Resolution RPC No. 1033

Amending the *Dane County Land Use and Transportation Plan* and *Water Quality Plan*, Revising the Central Urban Service Area Boundary and Environmental Corridors in the Village of Deforest, Dane County

**Map 1 Amendment
to the Central
Urban Service Area,
Village of DeForest**

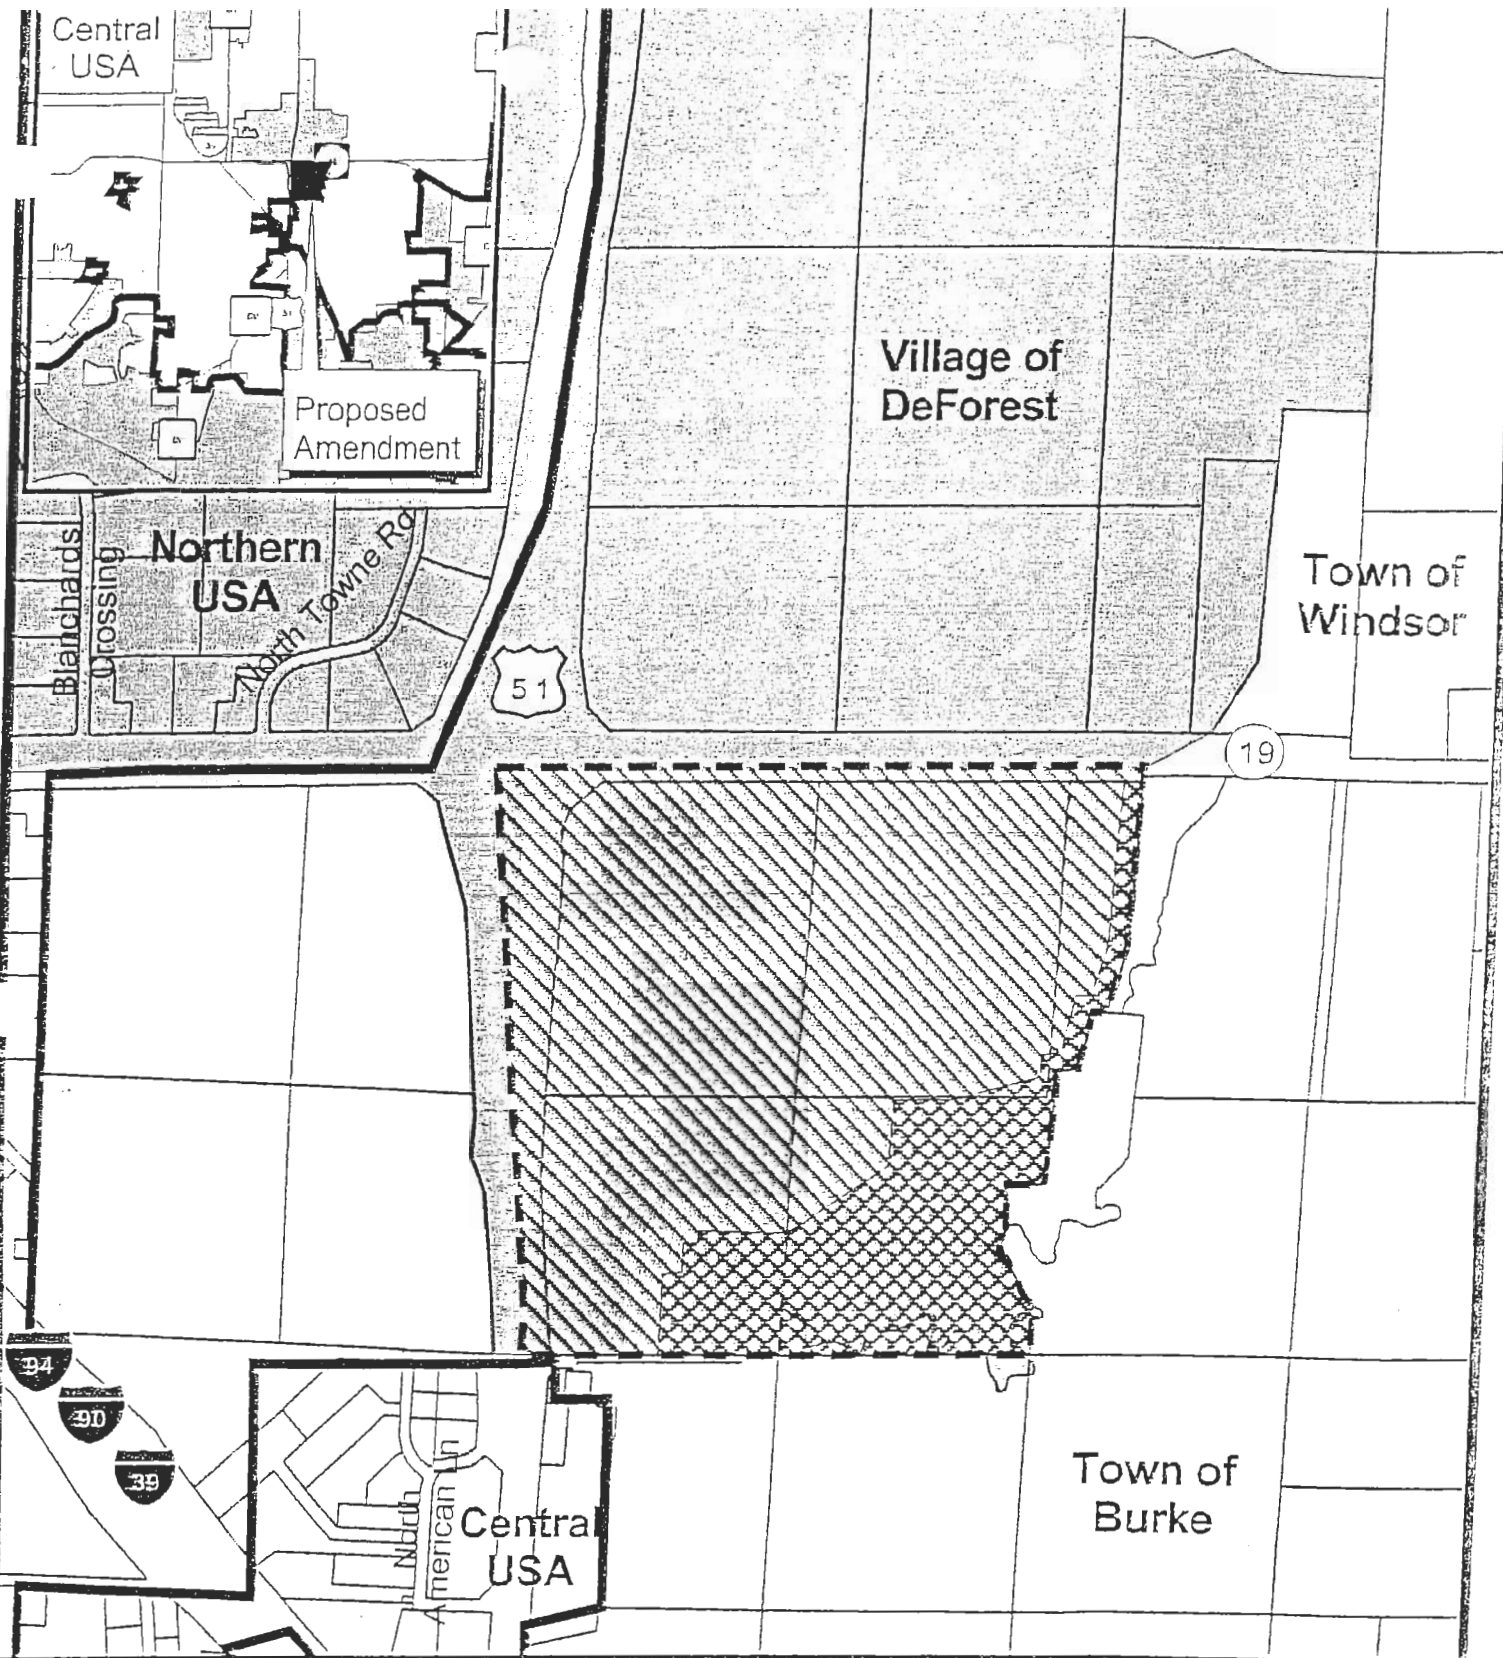
1. Submit a detailed stormwater plan for DCRPC and DCLCD staff review and approval prior to development. Stormwater measures should include the following:
 - Construction phasing to prevent unnecessarily large areas of exposed and disturbed ground.
 - Stormwater quality management practices to provide 80% sediment removal for up to a 5-year storm event.
 - Infiltration practices to provide 82.6 acre-feet of infiltration per year to mitigate the impacts of groundwater withdrawal and diversion.

- Infiltration practices to mitigate the impacts of lost recharge due to impervious areas, based on a detailed and quantitative assessment of the extent of groundwater recharge from the site in its present (agricultural) state.

- Stormwater quantity management practices to maintain pre-development rates of runoff for all storms up to and including the 100-year storm.
 - Install stormwater quality ponds prior to other land disturbance.

- Protect infiltration areas from compaction and sedimentation.
 - Provide deep tilling of all open space and infiltration areas.
 - Provide mitigation for thermal impacts of stormwater prior to discharge.

- Stormwater management measures to be publicly managed, or a perpetual legal maintenance agreement finalized with the Village.
 - Place all stormwater management areas, including the open space areas, recharge areas, and infiltration areas, in an easement to be perpetually protected from development, or dedicate to the public for conservation purposes. Changes to the open space area would constitute a "minor change" to the environmental corridors if they meet DCRPC environmental corridor guidelines and maintain the percentage of open space area. The oak knoll in the south portion of the amendment area should remain in environmental corridors unless removed as a "major change."

2. Designate all open space areas, stormwater management areas, 75-foot wetland and shoreland buffer areas, and the buffer for the tributary along the east border of the amendment area as environmental corridors.

3. Increase the upland buffer for the tributary along the east border of the amendment area to 200 feet, especially where the tributary bows to the west and along the old carp pond.
